Addendum No. 1

Savade Pond Boat Launch, Windsor, Maine State of Maine Department of Inland Fisheries & Wildlife

April 15, 2015

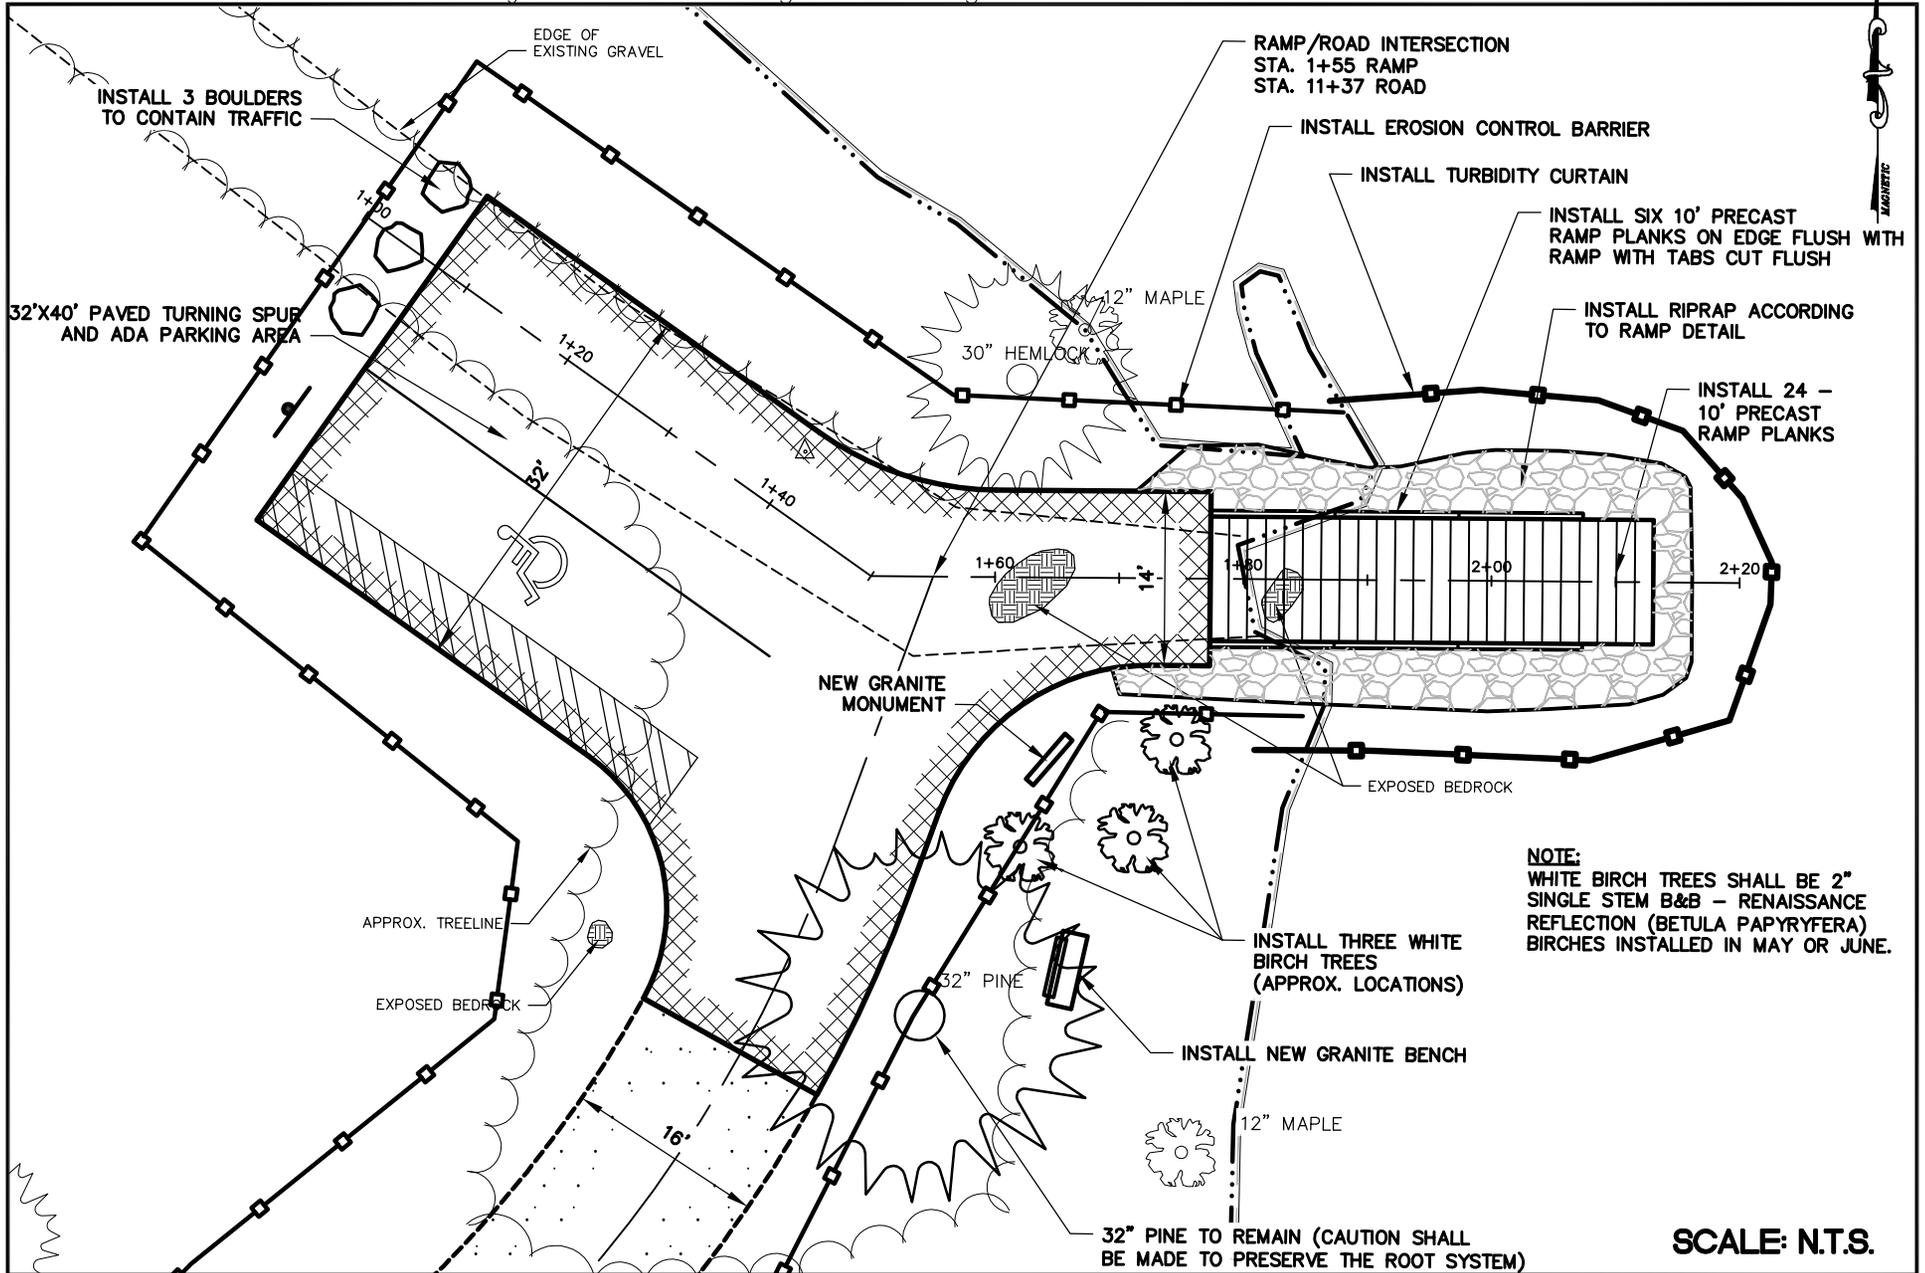
6. The attached drawing (Figure 1) provides clarification for the location of the turbidity curtain which was not included in the original drawings. Note: The gravel road is 14' wide to the parking area and 16' wide from the parking area to the launch area.
7. The Town of Windsor Road Entrance/Culvert Permit is attached.
